V2 - SDP-24-06

# ROLESVILLE CROSSING

## AMENITY CENTER (OS 1006 & OS 1007) CONSTRUCTION DRAWINGS

PROJECT NUMBER: LEN2026  
SDP-24-06  
DATE: JULY 1, 2024

**SHEET**  
**AMENITY UTILITY PLAN**

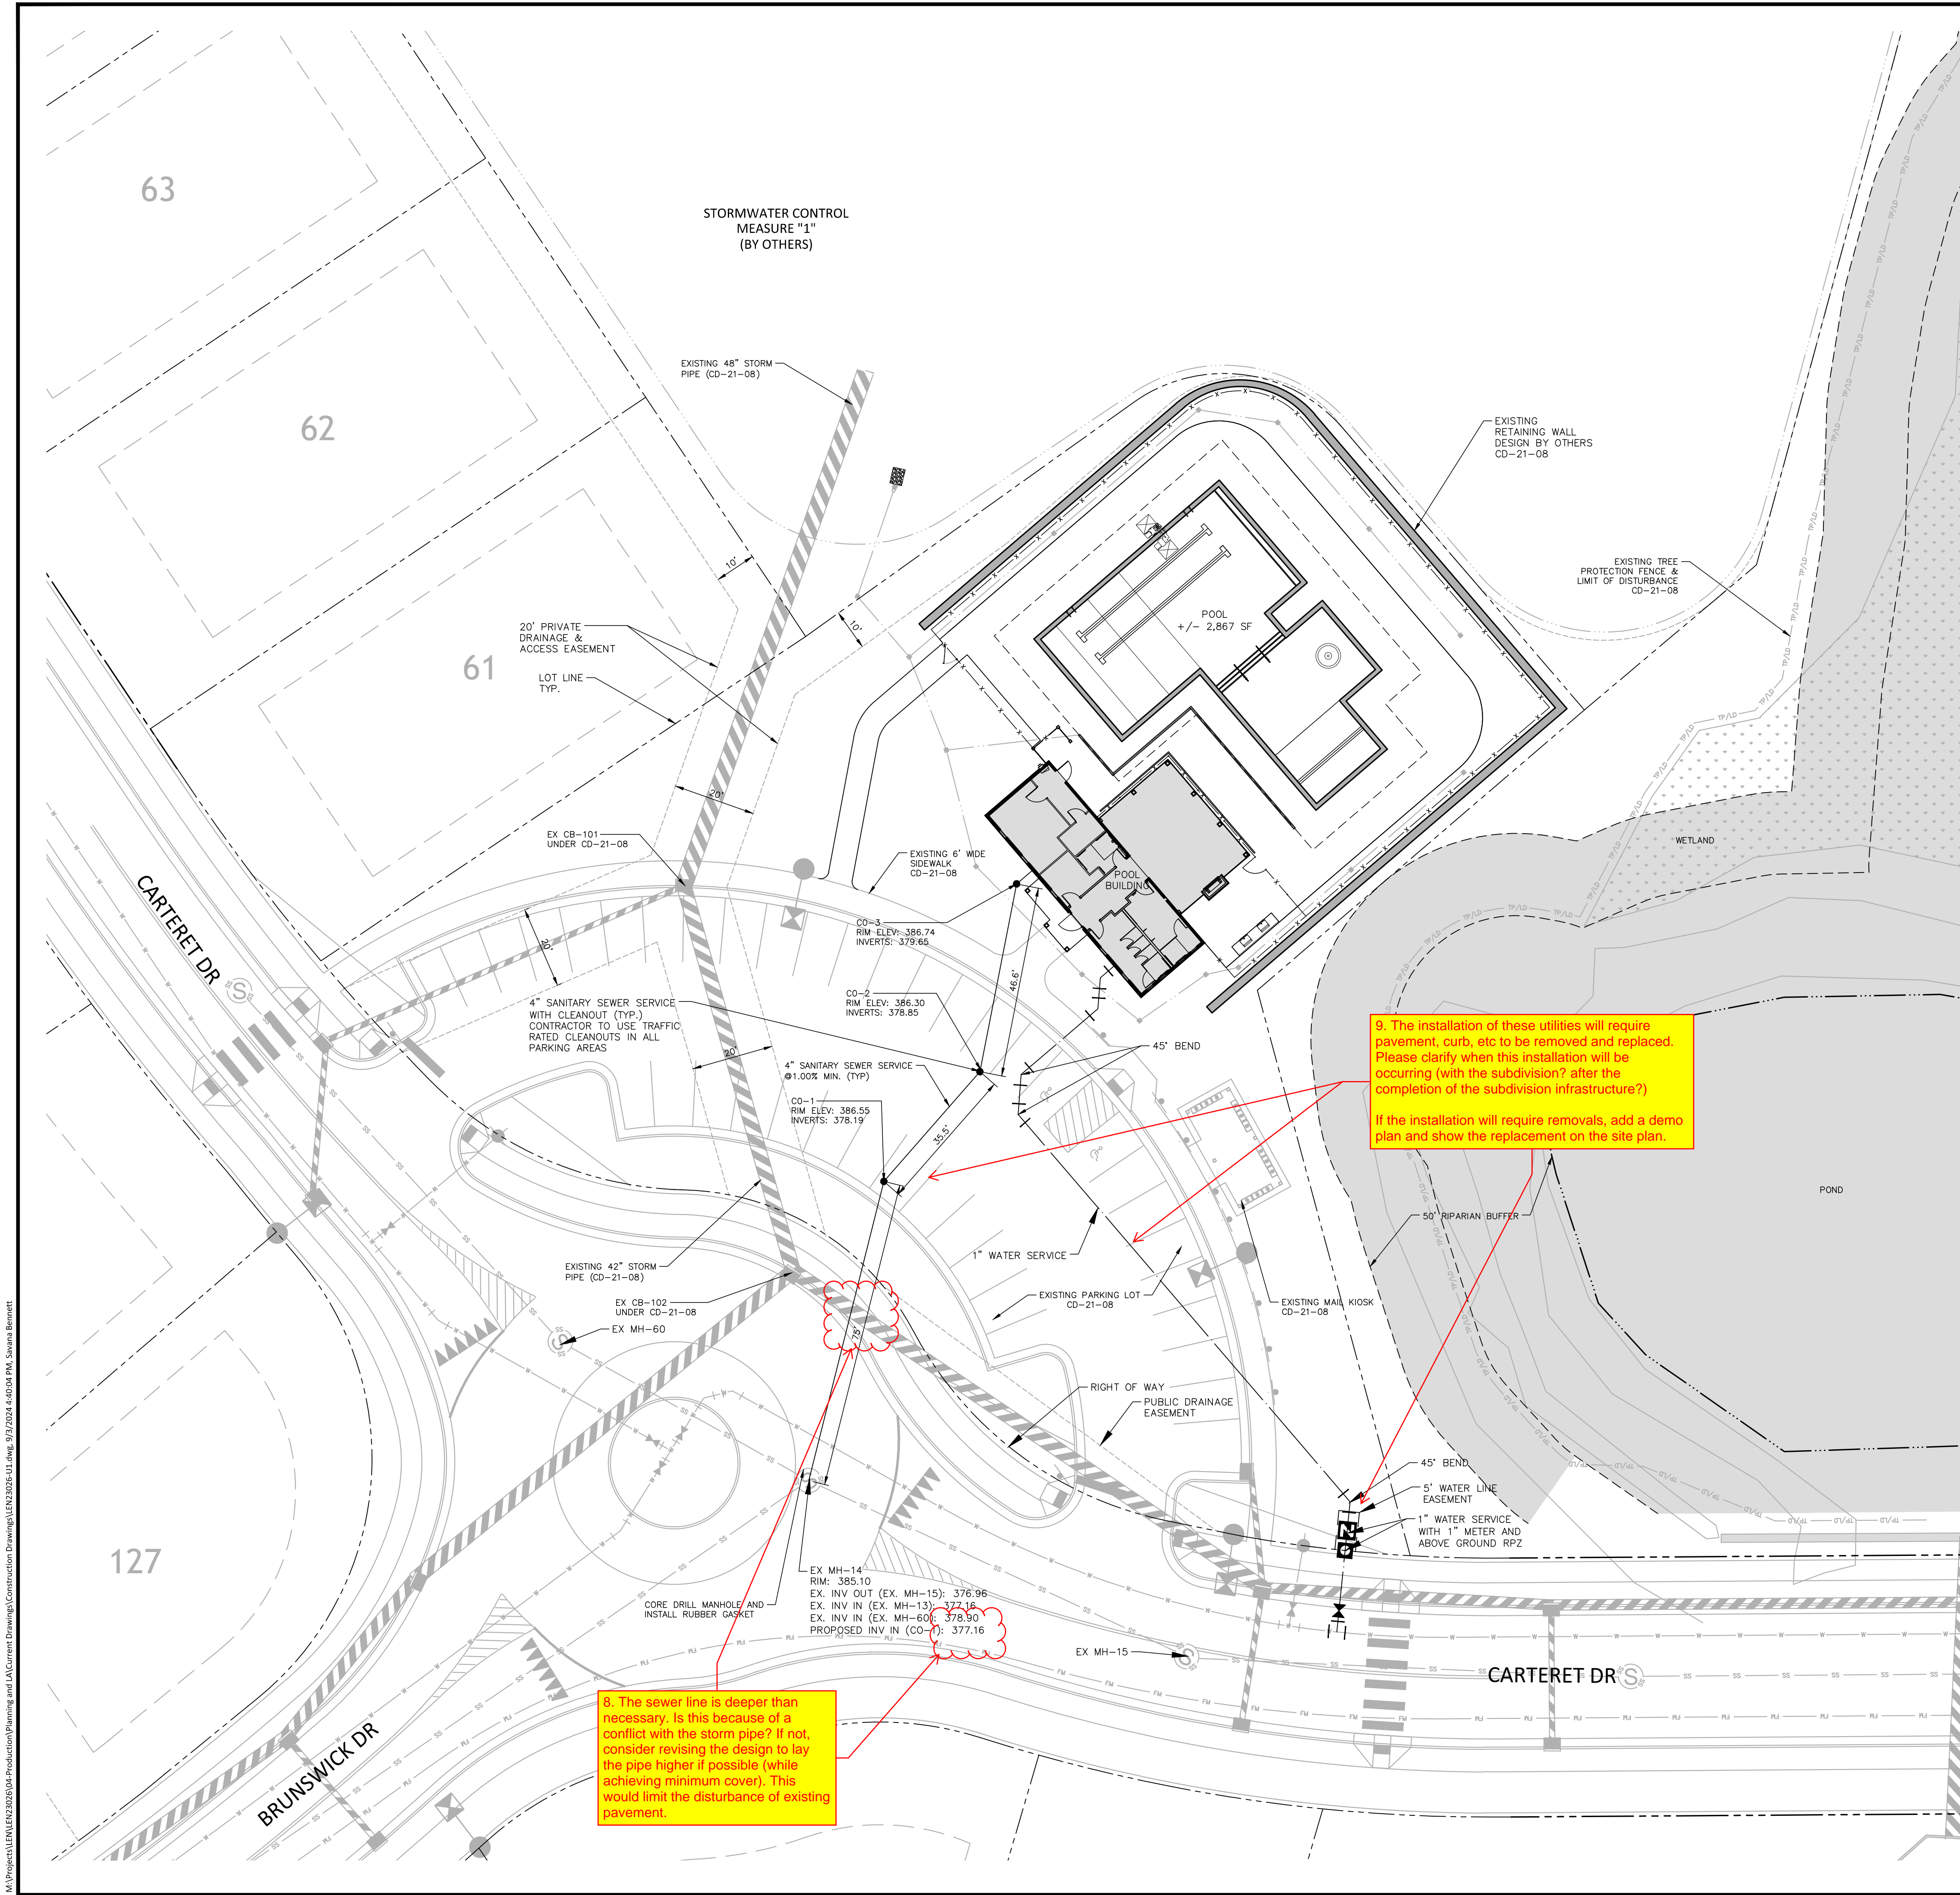
9. The installation of these utilities will require pavement, curb, etc to be removed and replaced. Please clarify when this installation will be occurring (with the subdivision? after the completion of the subdivision infrastructure?)  
If the installation will require removals, add a demo plan and show the replacement on the site plan.

8. The sewer line is deeper than necessary. Is this because of a conflict with the storm pipe? If not, consider revising the design to lay the pipe higher if possible (while achieving minimum cover). This would limit the disturbance of existing pavement.
